**RE: Moran Development**

This letter includes our responses to comments received from City of Mercer Island regarding the Moran Development project on February 03, 2023. We have reviewed and revised the plan set and associated reports/documents to reflect the changes requested.

Tree Retention Plan

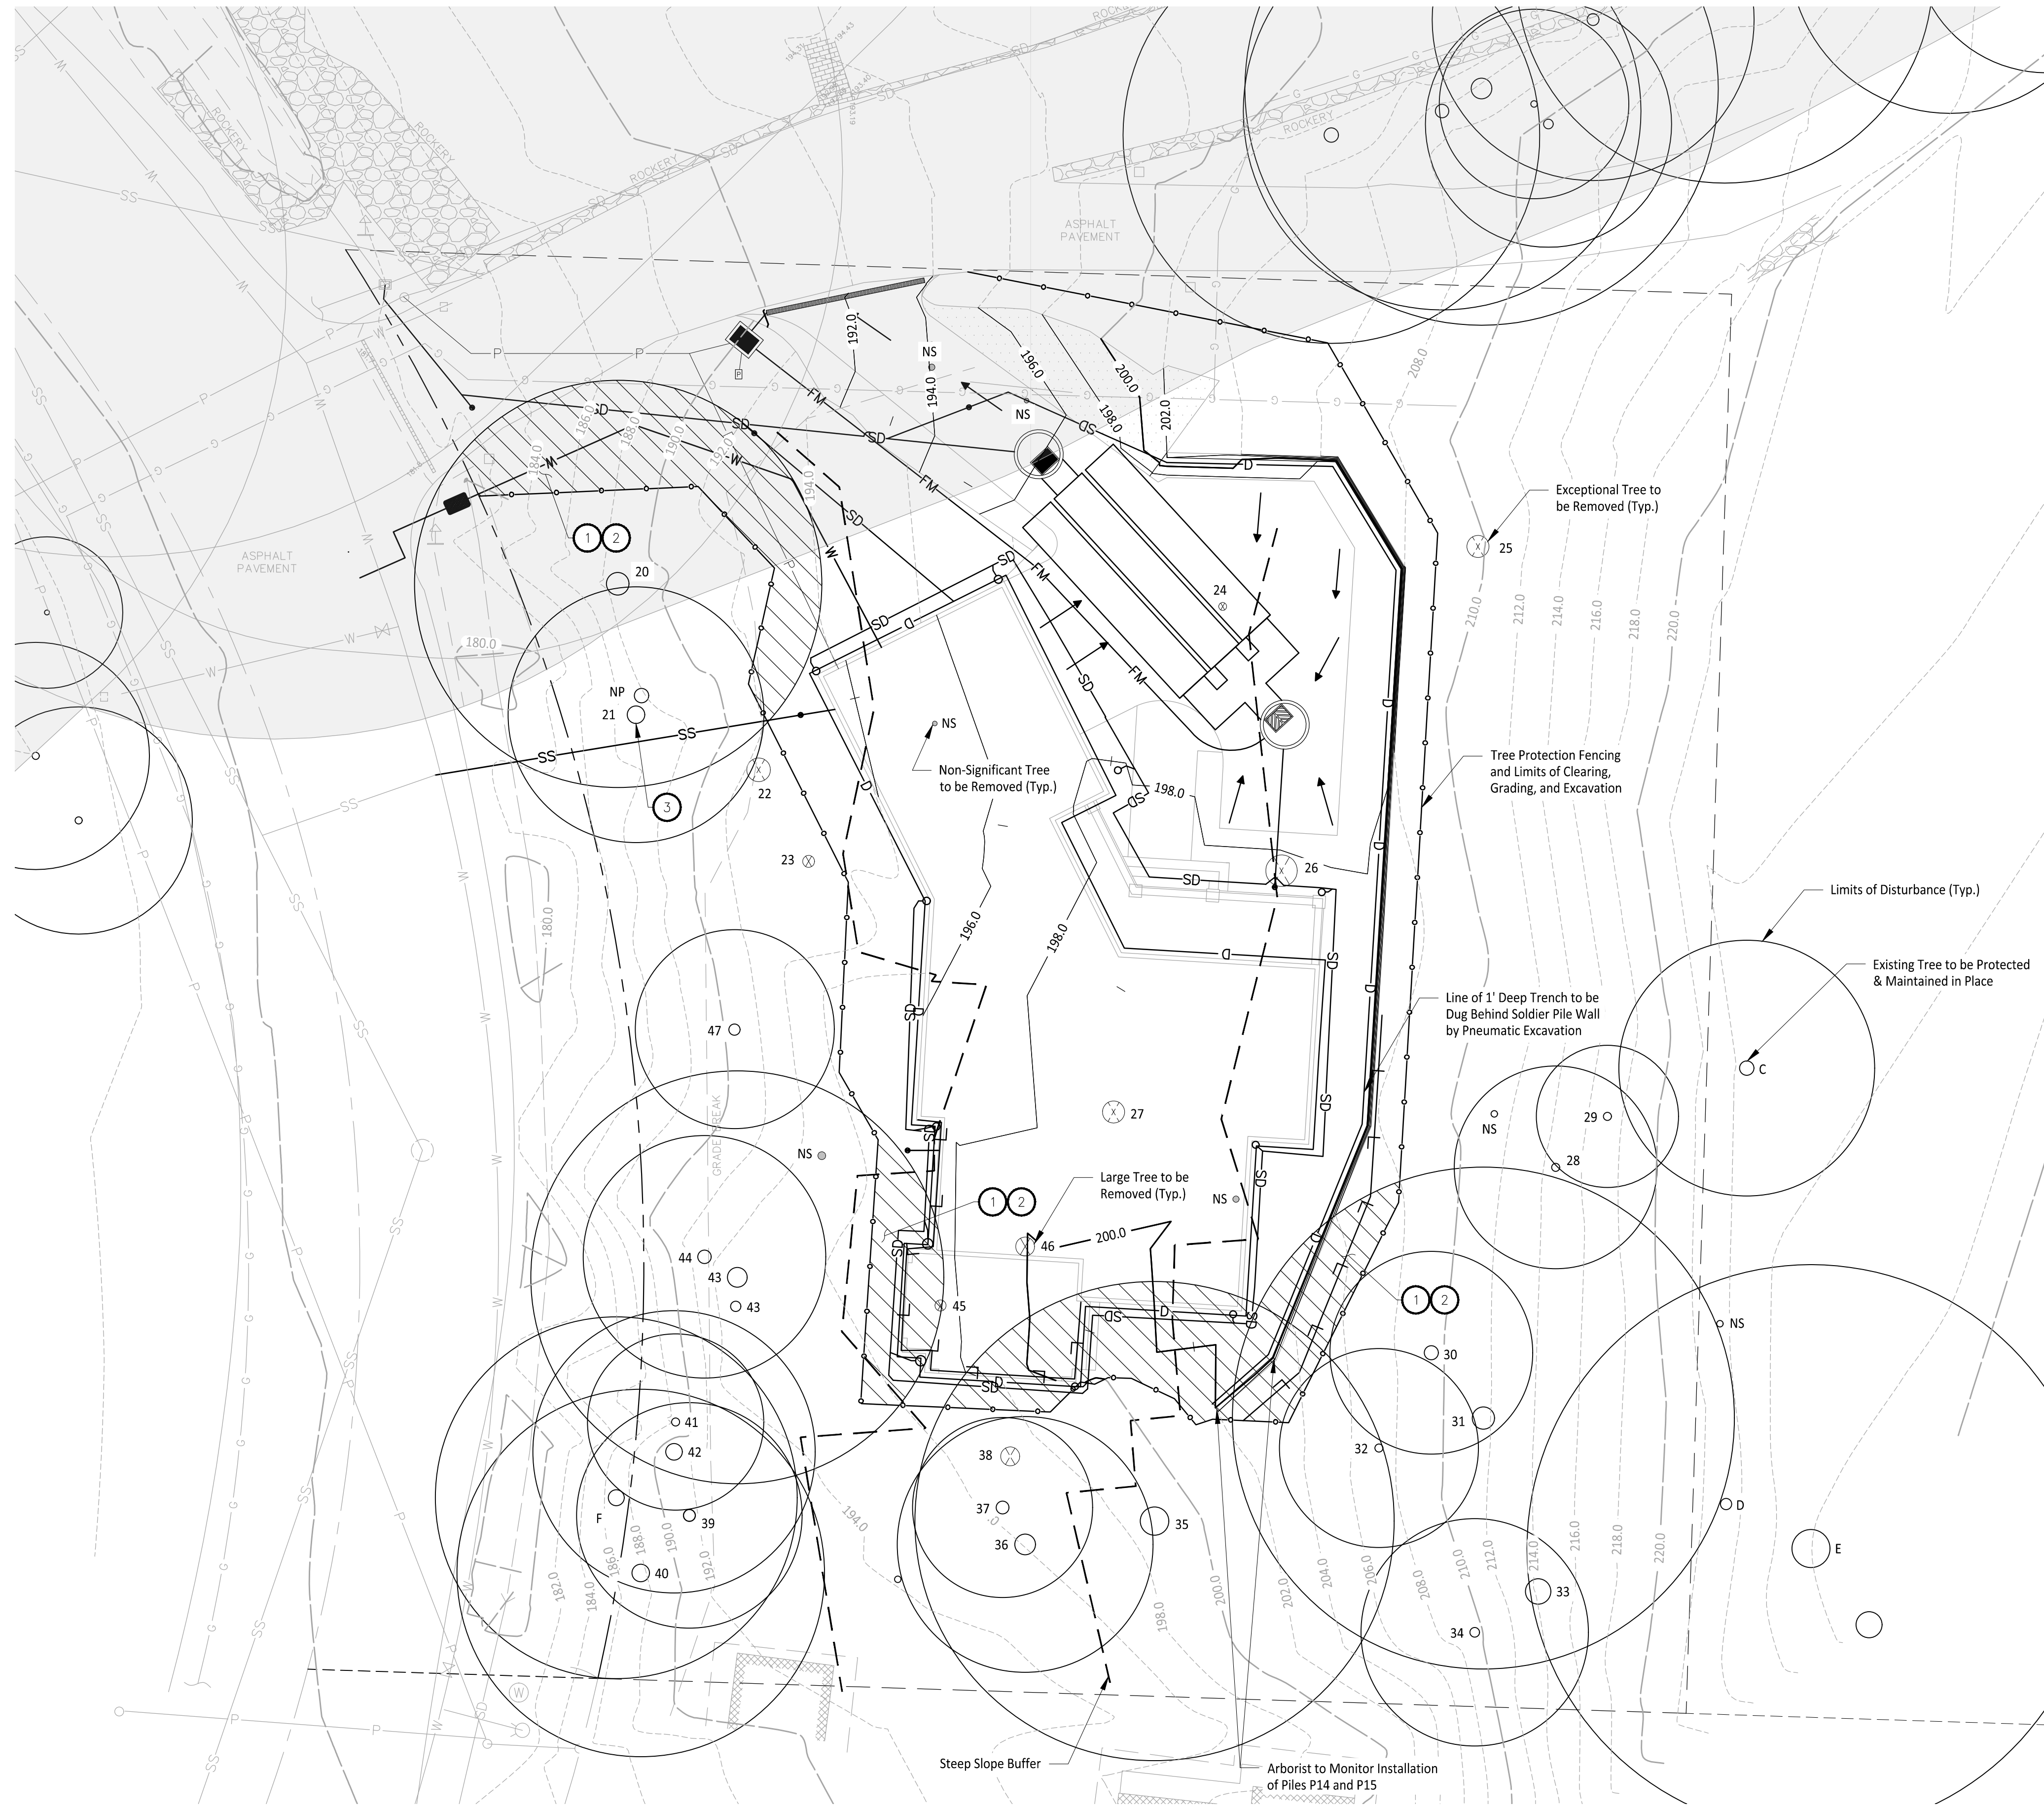
1. Update Tree Protection Plan with all civil information. Including all utilities, all grading and retaining wall should be shown and kept outside of exceptional trees driplines. Show over excavation for retaining wall. HYPERLINK  
"[https://www.mercerisland.gov/sites/default/files/fileattachments/community\\_planning\\_amp\\_development/page/21988/treessubmittalchecklist.pdf](https://www.mercerisland.gov/sites/default/files/fileattachments/community_planning_amp_development/page/21988/treessubmittalchecklist.pdf)"treessubmittalchecklist.pdf (mercerisland.gov)

2. Either move all utilities outside tree protection zones. Or call out tunnel/bore within trees driplines. And move water meter or install with air excavation and arborist supervision. Move tree protection fence at the edge of the utility easement to protect tree 20. Remove grading that is proposed within exceptional tree 20's dripline, grading/excavation can be in the easement. See comment 1, exceptional trees must be protected or protected according to MICC19.10.080. And comment 3 requiring all work and trees to be on one plan.

**Response: Added Tree Protection plan to civil sheets. Utilities, grading, and retaining wall shown and kept outside of exceptional tree driplines. Over excavation for retaining wall shown.**

**Response: Utilities moved outside tree protection zones. Sewer line called out to be excavated using pneumatic or hydro excavation or hand excavation.**

**ATTACHMENT 1**  
**CITY OF MERCER ISLAND**  
**ON-SITE DETENTION SYSTEM WORKSHEET**  
**(FOR NEW PLUS REPLACED IMPERVIOUS**  
**AREA OF 9,500 SF OR LESS)**

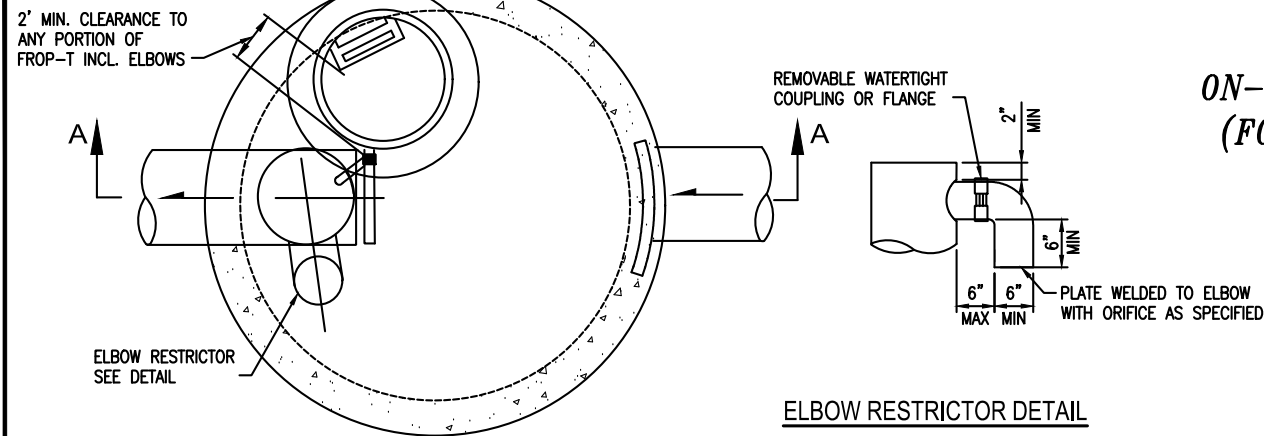
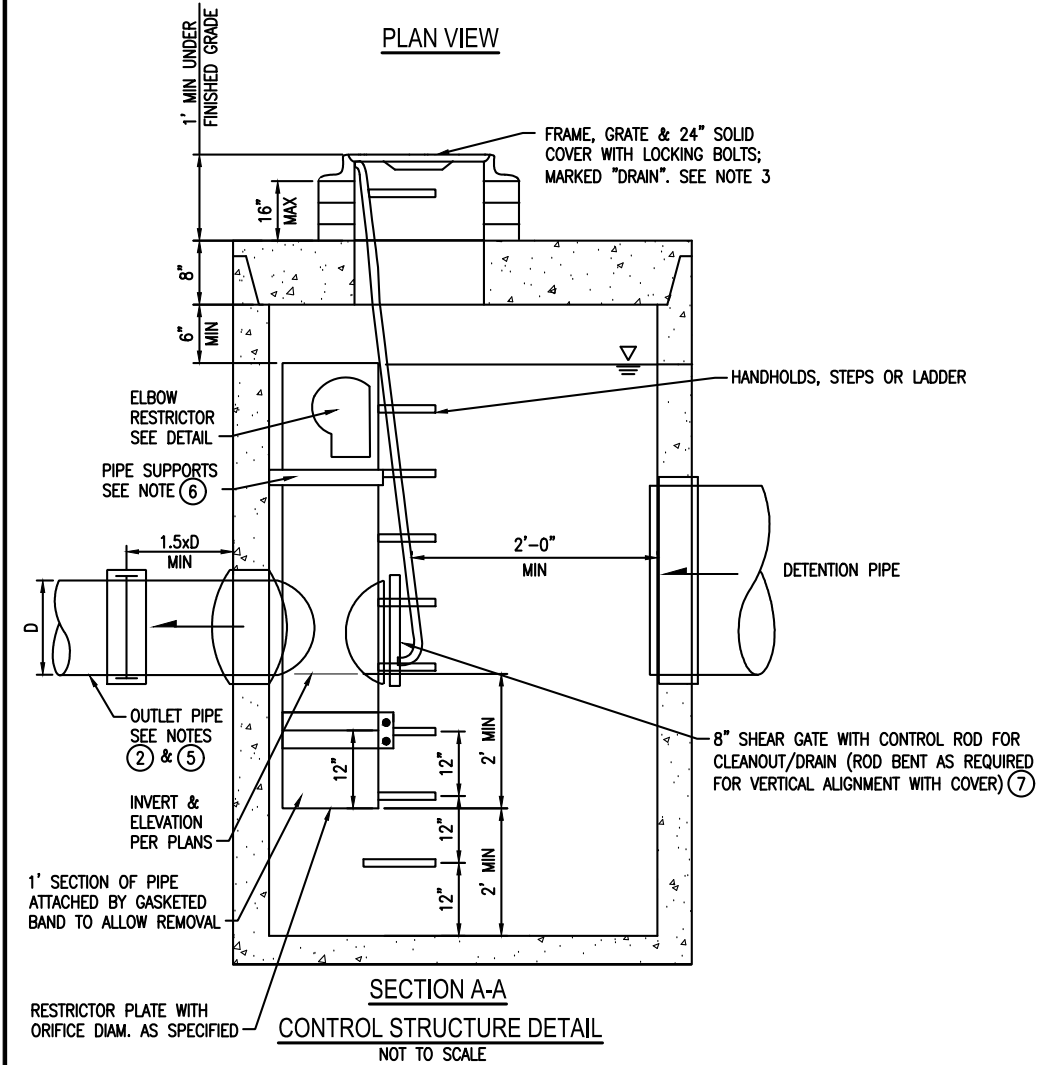
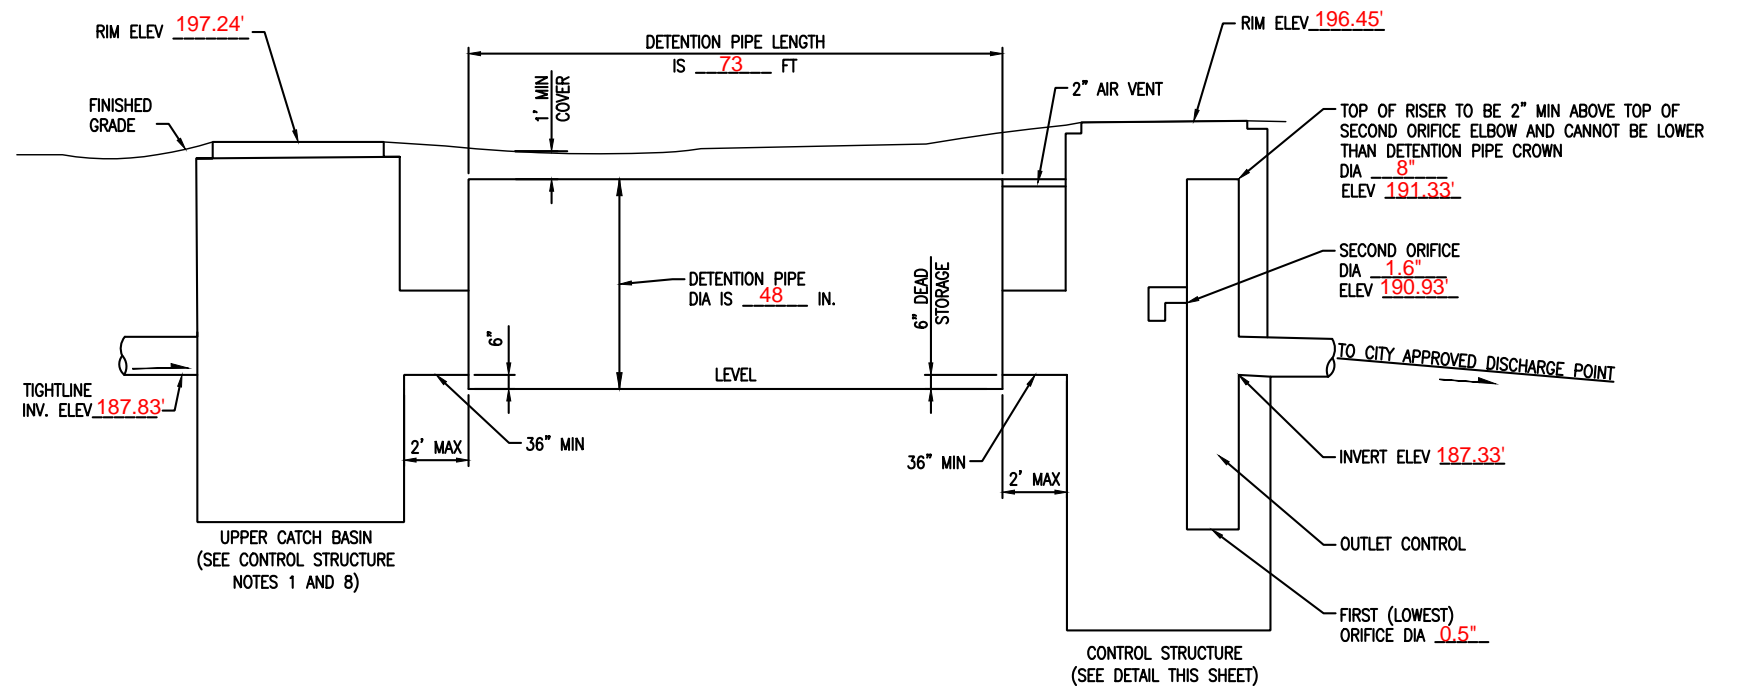
21. Measuring the roof area and driveway area on the architectural plans, the impervious surface area is approximately 4,100 SF. Report also indicates over 4000 SF. Please confirm and revise design and report.

Noted that there is a total of 66' detention pipe length which exceeds the required 62' - but we will require the 73' length if the impervious area exceeds 4,000 sf.

22. Riser diameter minimum 8" to match 8" shear gate.

23. 2nd orifice diameter should be 0.8" to match table above (for current impervious area).

Response: The impervious surface area has been updated to 4,039 SF. Design of detention tank system has been updated to have a total of 73.5' detention pipe length, 73' is required.

Response: Riser diameter updated to 8".

Response: 2<sup>nd</sup> orifice diameter updated to be 1.6" to match table
